# Technical Bulletin

May 3, 1965

SUBJECT: \* IMPROVED REVERBERATION RESTRAINT BRACKET

19 L-100 Series  
M-100 Series  
S-100 Series

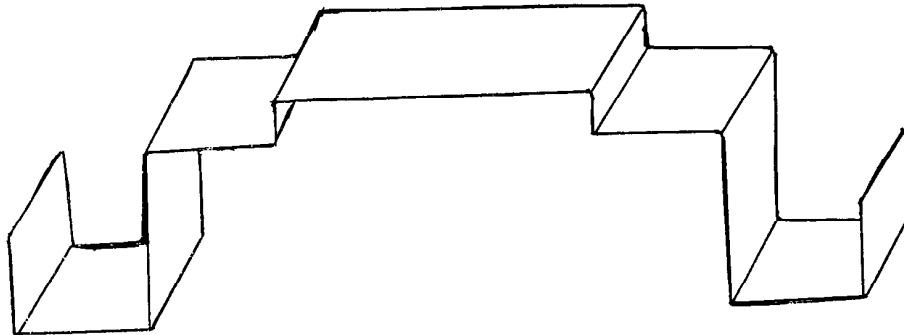
An improved method for immobilizing the reverberation unit has been devised to replace the present corrugated inserts, and will be on all units mentioned above in the near future.

It will be a formed metal bracket, and will be locked in place by bending the two end tabs over the outer edges of the "R" unit body.

This bracket can, and should be re-used whenever the organ is to be moved any appreciable distance.
